Subject: ACTIVE DRIVING DISPLAY VIBRATES AND/OR CANNOT BE ADJUSTED TO A VIEWABLE POSITION	Bulletin No: 09-026/15
	Last Issued: 07/01/2015

- This bulletin supersedes the previous bulletin 09-018/14 issued on 03/12/14. The APPLICABLE MODEL(S)/VINS, DESCRIPTION, REPAIR PROCEDURE, PART(S) INFORMATION and WARRANTY INFORMATION have been revised.
- Changes are noted below in Red beside the change bar.

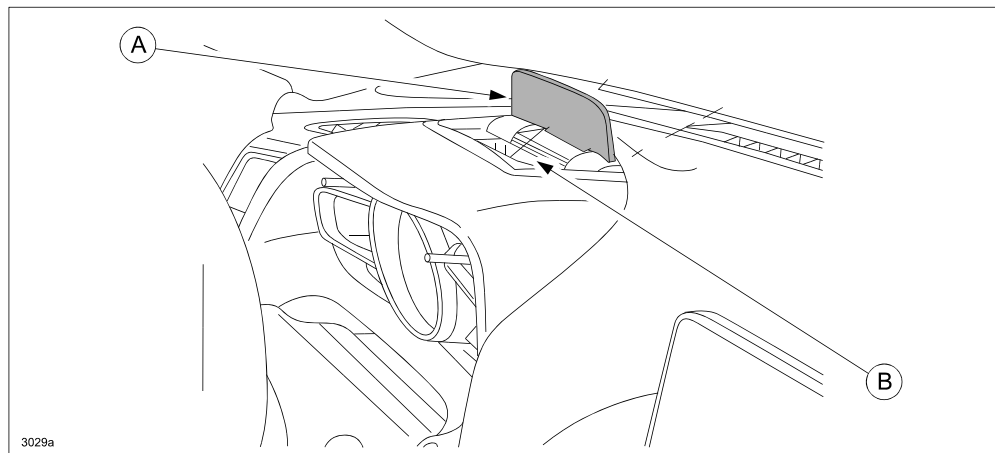
Some customers may complain that the Active Driving Display (A) vibrates when driving over a bump and/or cannot be adjusted to a viewable position using the commander switch. This is caused by the axis of the Active Driving Display popping out of position if the customer manually opens or closes the display, or closes the display with objects placed in the storage area (B) for the display.

To correct the problem, the shape of the shaft and bearing part has been changed to increase the insertion force, thereby making the display harder to pop out of position.

View from driver's seat

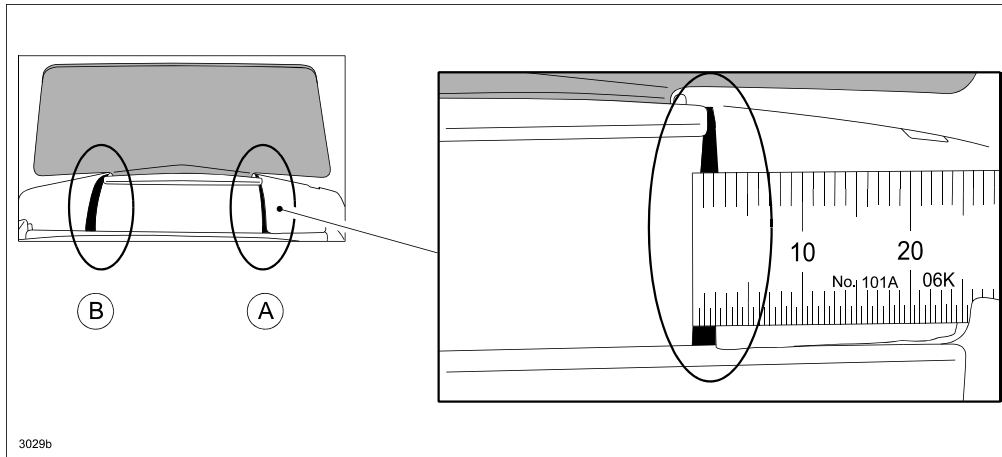
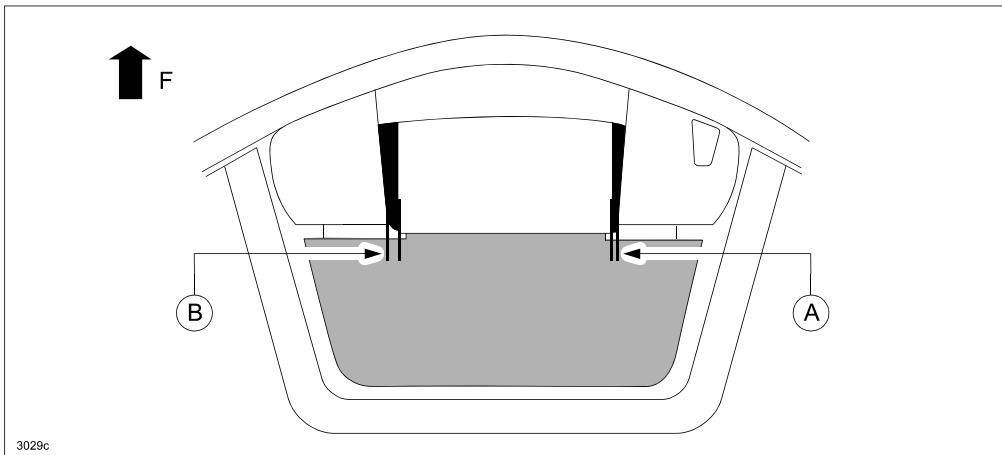
1. Verify customer concern.
2. Visually compare the right and left side clearance between the Active Driving Display and the upper cover.
 - If the right side clearance (A) is evidently smaller than the left side (B) as shown, the Active Driving Display has popped out of position. Proceed to the next step.
 - If the clearances on both sides are almost the same, this Service Bulletin is not applicable. Inspect for other causes.

3. Replace the Active Driving Display (Heads Up Display) with a modified one according to the instructions on MS3 online or the Workshop Manual (section 09-10 ACTIVE DRIVING DISPLAY REMOVAL/INSTALLATION).
